4000 Series Service Supplements

4000 Series Industrial Engines

Contents Page

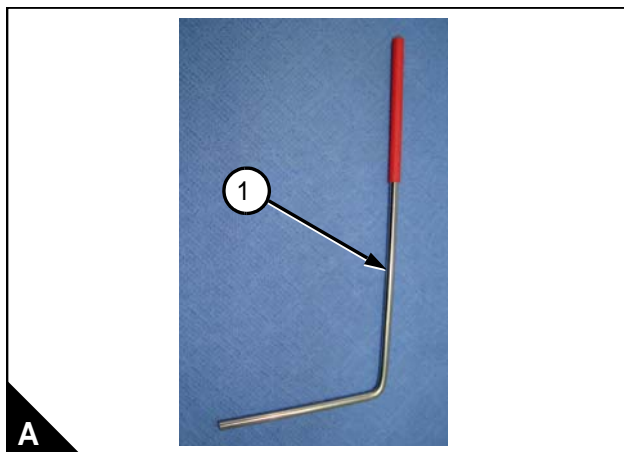
Within the Operation and Maintenance Manuals (OMM) SEBU8190-00 and SEBU8604-00 for the engines listed, incorrect information has been given.

In Overhaul (Major) the manuals states:

Generally, a major overhaul is performed at 32,000 hours. This information is not correct. Generally, a major overhaul is performed at 64,000 hours. Please amend your OMM in order to show this information.

Illustration 1

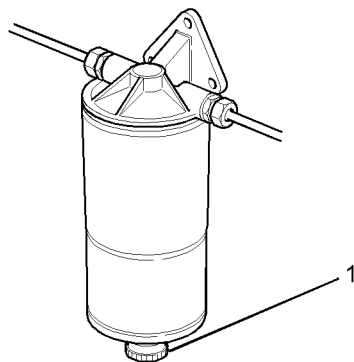
There have been isolated incidences of fuel leaks from the drain of the primary fuel filter/water separator after completing maintenance checks.

A new process has been produced that requires a recommended torque for the drain plug.

2. Loosen the drain plug (1). Allow the fluid to drain into the container until fuel that is free of water is being drained.
3. Tighten the drain plug to a torque of 1.5 N·m to 2 N·m (13.3 lb in to 17.7 lb in). Dispose of the drained fluid in accordance with local regulations and mandates.
